DECOMMISSIONING OF URANIUM MINE TAILINGS MANAGEMENT AREAS IN THE ELLIOT LAKE AREA

Report of the Environmental
Assessment Panel

June 1996

FIGURE 4: QUIRKE WMA SITE PLAN

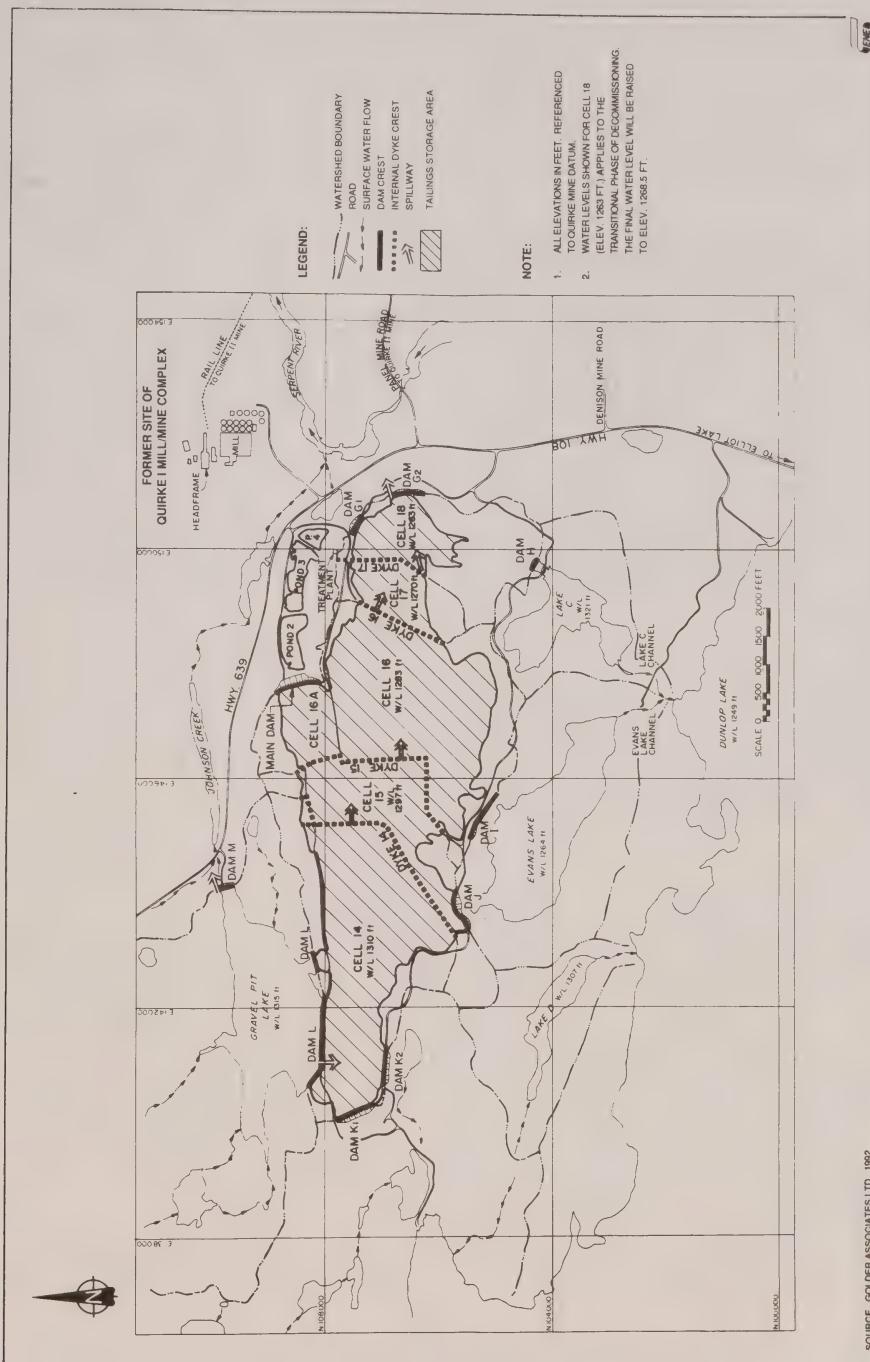
As discussed in Section 5.2.2, Quirke WMA comprises a series of five internal "cells" separated by dykes between 3 m and 4.5 m in height, with eight embankment dams around the periphery to provide containment. Of these dams, six are founded on grouted bedrock (G1, I, J, K1, K2, L), and two on dense overburden deposits (G2 and Main Dam). The maximum dam height is 26 m (Main Dam), and all perimeter structures have been designed and constructed as water-retaining structures, that meet or exceed the normal standards of modern practice. To prevent overtopping, spillways have been designed to handle floods resulting from the PMP design event of 424 mm precipitation in a 12-hour period. Internal drains and filters are provided to protect against internal erosion ("piping"). All dams are built of and founded on materials that are expected to remain physically and chemically stable. Monitoring to date has confirmed that the dams are performing as designed. Studies of the effects of changing conditions - including increased seepage, climate change, poor maintenance, etc. - have indicated that the structures are robust and capable of performing adequately despite such changes. Credible studies have concluded that the risk of having unplanned discharges of water or wastes from the Quirke WMA is in the order of one in one million, annually, and that the hazards resulting from an extreme event would be minor and readily mitigated. The panel concurs with these conclusions.

Details of an approved program of scheduled and contingency monitoring and maintenance must be worked out during the short-term and transition phases of operation, and should be based initially on meeting all recommendations of the proponent's consultants, as a minimum requirement. In particular, the panel would draw attention to the importance of ensuring that adequate monitoring instrumentation is installed in the containment structures, maintained in good working order and regularly monitored, and that a comprehensive plan of continual surveillance and maintenance is put into place. Some minor additional monitoring of the dyke structures is recommended by the panel, to confirm the proponent's expectation that there is no ongoing settlement of the dykes.

Water balance calculations show that the maintenance of water cover at Quirke will not be significantly affected by the predicted seepage rates. However, one situation that is unique to Quirke is the presence of the internal dykes separating the cells of the WMA. In particular, for Cell 14 (the most upstream cell), seepage from this cell beneath the dyke will reduce the water available for maintenance of the cover. Analyses by Rio Algom indicate that the system will still perform satisfactorily. However, in the event that these predictions are in error, there are a number of viable remedial actions that can be implemented. Make-up water from Gravel Pit Lake could be added as a temporary measure. More permanent measures could include construction of an upstream seepage control blanket, or of a cut-off wall beneath the dyke. The panel recommends that careful analysis of seepage losses from Cell 14 be undertaken during the short-term and transitional phases of decommissioning to determine if remedial actions are necessary.

R8. For the Quirke WMA, monitoring is required to verify that settlement of the internal dykes has ceased or is negligible.

FIGURE 5: PANEL WMA SITE PLAN

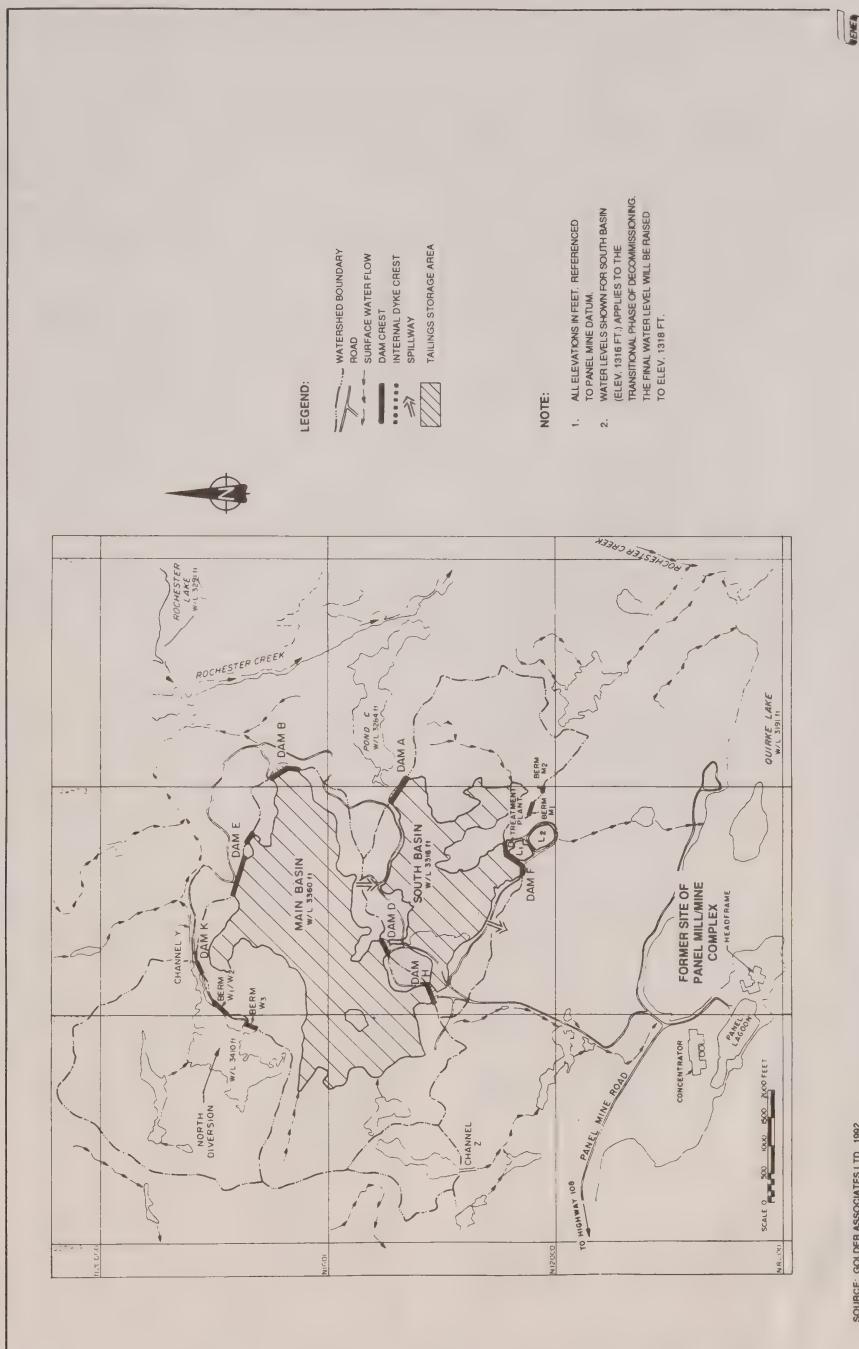
As noted in Section 5.2.3, the Panel WMA comprises two rock-rimmed basins, the Main Basin and the smaller South Basin, with a series of six perimeter containment dams (dams B, E, H and D in the Main Basin; dams A and F in the South Basin). All dams are founded on grouted bedrock except Dam B, which has a partial soil foundation. These structures have been designed and built as water-retaining structures that meet modern requirements. Four of the dams incorporate a synthetic membrane seepage barrier (Hypalon), in addition to other seepage barriers. In response to concerns that were raised that the longevity of Hypalon membranes was short in relation to the life of the WMA, the proponent has clarified that these membranes will not be relied upon for long-term seepage control. The spillway from the Main Basin to the South Basin, and an overflow spillway from the South Basin, are designed to handle floods resulting from the PMP design event.

FIGURE 6: DENISON TMA SITE PLAN

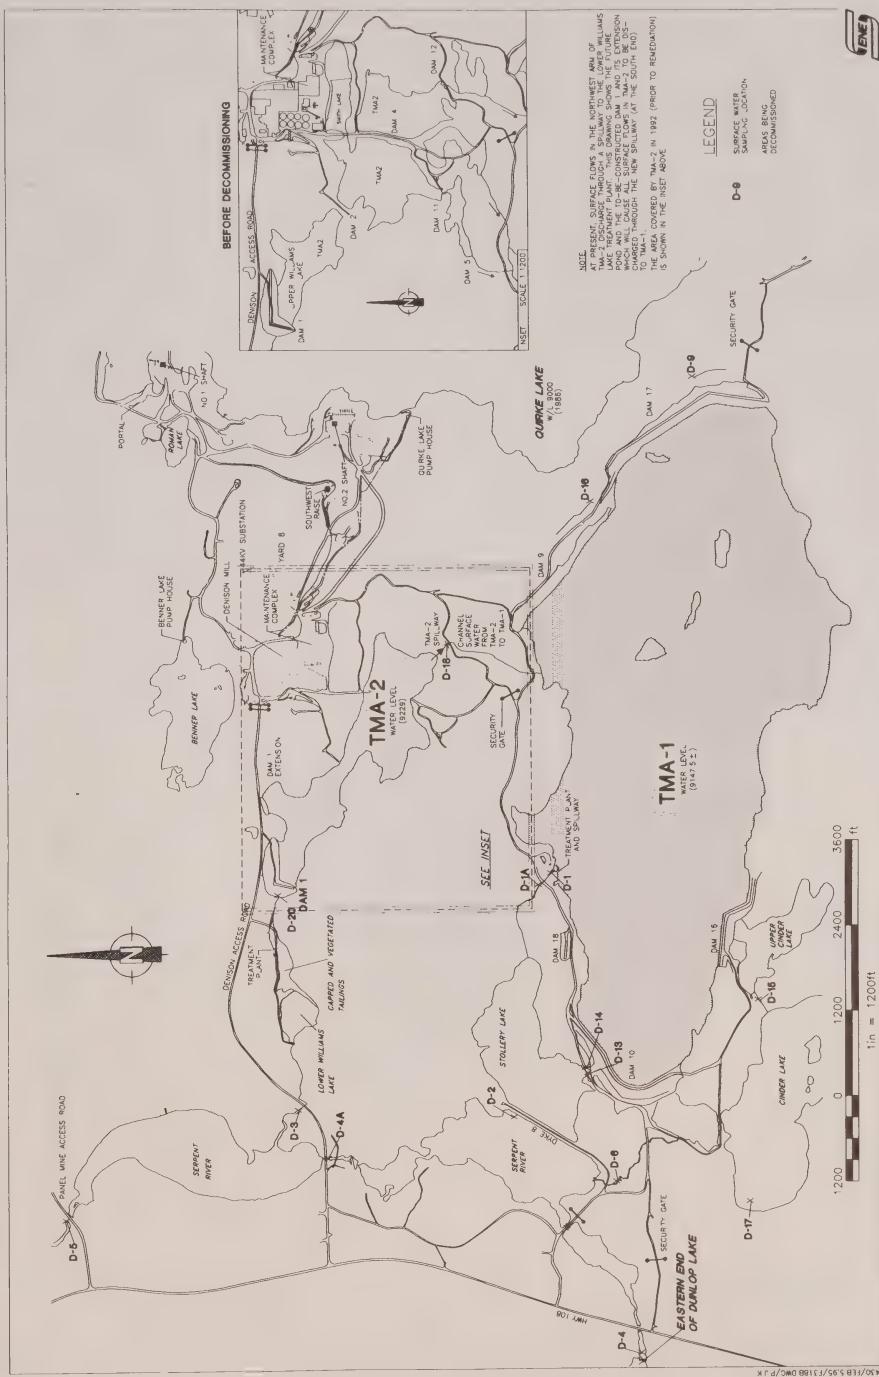
Relocation of approximately 1.5 million tonnes of tailings from the north part of the Denison TMA, called TMA-2, has been completed. The final configuration of TMA-1 and TMA-2 includes a series of five containment dams around TMA-1 (dams 9, 10, 16, 17 and 18), and one main containment dam for TMA-2 (Dam 1). Of these, dams 9, 16, 17, and 18 are fully engineered zoned earthfill dams, and appropriate analyses show them to be stable under postulated static and earthquake operating conditions. Dam 1 (TMA-2) and Dam 10 (TMA-1) both incorporate Hypalon membranes as a seepage barrier.

Dam 10, within TMA-1, has been the subject of particular scrutiny. This dam does not contain an earth-core seepage barrier, and has relied on a Hypalon membrane for seepage control. In addition, while the dam is calculated to be fully stable under static conditions, the computed factor of safety under earthquake conditions is somewhat below normal standards of acceptance. This situation, for both static and dynamic conditions, would be made worse if the Hypalon liner became ineffective in the future. For these reasons, a series of modifications to the dam have been proposed, including construction of an upstream seepage-reduction berm and a downstream stability berm, and sealing of the existing decant tunnel beneath the dam. These proposals would result in estimated worst-case seepage quantities of about 6 L/s, and would also result in factors of safety that are acceptable by current standards of practice.

The panel concludes that the proposed modifications to Dam 10 are acceptable in concept. However, the long-term performance of Dam 10, which is of critical importance to the satisfactory decommissioning of TMA-1, will depend on the satisfactory implementation and longevity of these modifications. The panel recommends that particular care be

In relation to seepage, the most important structure at the Denison TMAs is Dam 10. As noted in Section 6.2.1.4, the panel has scrutinized this structure with particular care, as it does not currently contain an earth-core seepage barrier, and it is penetrated by a (sealed) decant tunnel. Seepage of about 21 L/s is occurring downstream of Dam 10, of which about 4 L/s is contributed from Cinder Lake. The primary concern is that seepage control currently relies on an embedded Hypalon membrane, of questionable longevity. If the membrane fails, seepage rates could rise to more than 75 L/s, jeopardizing maintenance of the water cover over TMA-1, and pore-pressure increases within the dam could jeopardize its stability.

Presuming that seepage control at Dam 10 is achieved, total seepage flows from Denison's TMA-1 and TMA-2 are estimated at about 12 L/s, a figure that must be confirmed. For these seepage flows, water-cover maintenance is not predicted to be a problem. Some treatment of seepage water will be required until it can be demonstrated that the quality of receiving waters is not deleteriously affected by direct discharge.

FIGURE 7: STANROCK TMA SITE PLAN

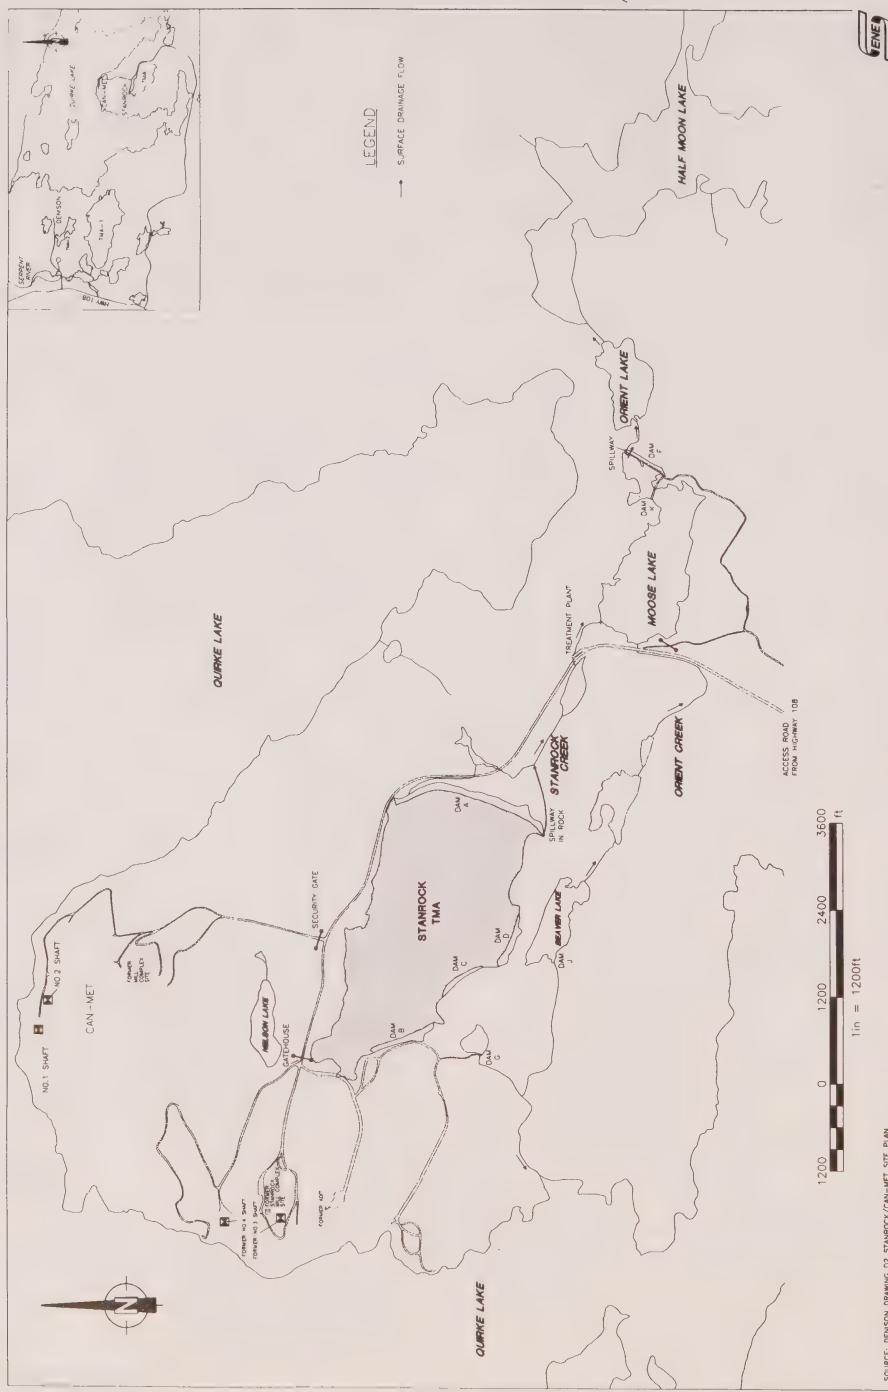
Currently, impervious containment structures are not in place around the Stanrock TMA. The proponent's proposed in-situ management plan requires that all of the existing pervious perimeter dams be replaced with engineered low-permeability zoned embankment dams, placed immediately downstream of the four existing dams (A, B, C and D). Such dams must, of course, be designed and constructed to meet rigorous seepage and stability standards, under both static and dynamic conditions. The panel recommends that the AECB arrange for timely reviews of design plans and construction procedures to ensure that these conditions are met. In particular, the panel emphasizes the importance of minimizing seepage losses from the Stanrock site, in order to maintain a high phreatic surface within the wastes and to ensure that potentially acid-generating materials are kept in a saturated condition (Section 6.2.4).

The proposed use of a vegetative cover on the Stanrock tailings basin, along with the saturation of the bottom portion of the tailings, will introduce an increased demand for water under drought stress. Whereas the stress on the water covered WMAs under drought conditions is caused by the loss of water solely through evaporation, the Stanrock basin, with its vegetative cover, will lose water due to transpiration as well as evaporation. During the growing season, transpiration loss will be greater than evaporation loss. To offset the combined evapotranspiration loss and to provide replacement water, this TMA may require supplementary water to irrigate the vegetative cover and to bring the elevated water table back to its optimum operating level.

The decommissioning plan for the Stanrock TMA does not include a pond. The surface will be vegetated. Therefore, the precipitation and melt run-off water will flow across the tailings surface and, after a short residence period, will exit through a spillway to Moose Lake. From there the discharge will flow via Orient Lake to Half Moon Lake. The modelling calculates the incremental levels of radium-226 in Half Moon Lake will be 0.02 Bq/L in 50 years, 0.03 Bq/L in 100 years, 0.08 Bq/L in 500 years and 0.06 Bq/L in 1000 years after closure. The 1994 level of radium-226 in Half Moon Lake was 0.17 Bq/L, which is substantially below the provincial water standard of 1 Bq/L.
